Rezoning Transportation Analysis

Petition Number: #2022-161

General Review Information

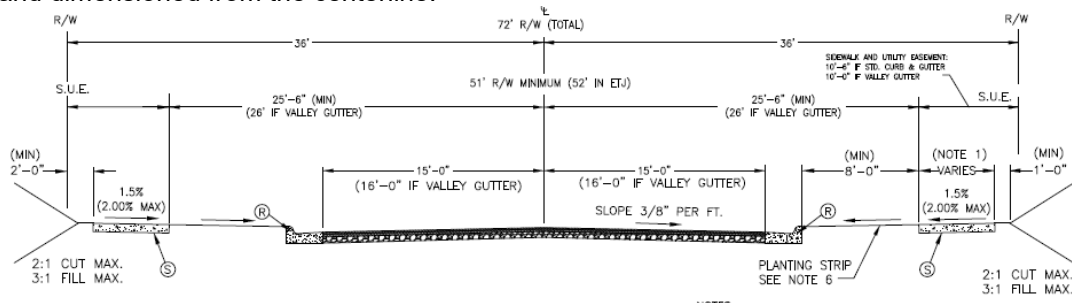
- a. ~~**Steele Creek Road:** Location of the future curb and gutter to be installed at 33 feet from roadway centerline to accommodate the Charlotte Streets Map roadway typical section of four plus lane avenue with shared use path. The future curb and gutter should be shown on the plan and dimensioned from the centerline.~~

- b. ~~**Parkside Crossing:** Location of the future curb and gutter to be installed at 17.5 feet from roadway centerline to accommodate the Charlotte Streets Map roadway typical section of collector street per CLDSM U-07. The future curb and gutter should be shown on the plan~~

and dimensioned from the centerline.

Label and dimension the curb and gutter from the centerline for each road on the site plan.

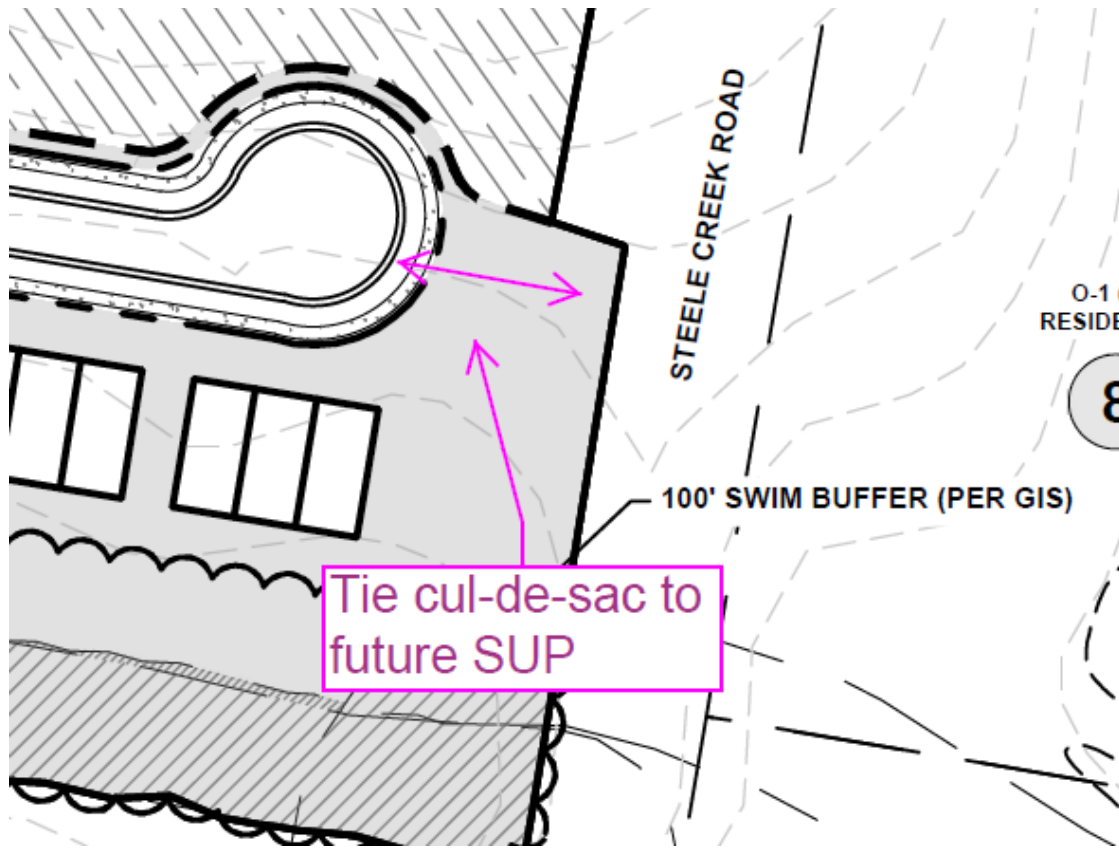
~~4. Revise site plan and conditional note(s) to show the previously approved sidewalk and the curb and gutter along Parkside Crossing.~~

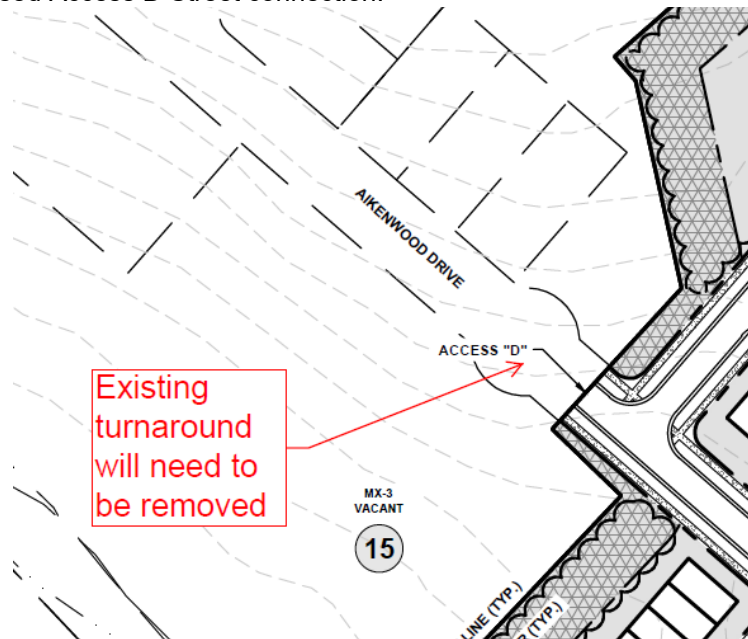
~~6. CDOT REQUEST: Revise site plan and conditional notes to commit to providing a 12-ft multi-use path connection from the proposed cul-de-sac to the proposed MUP along Steele Creek~~
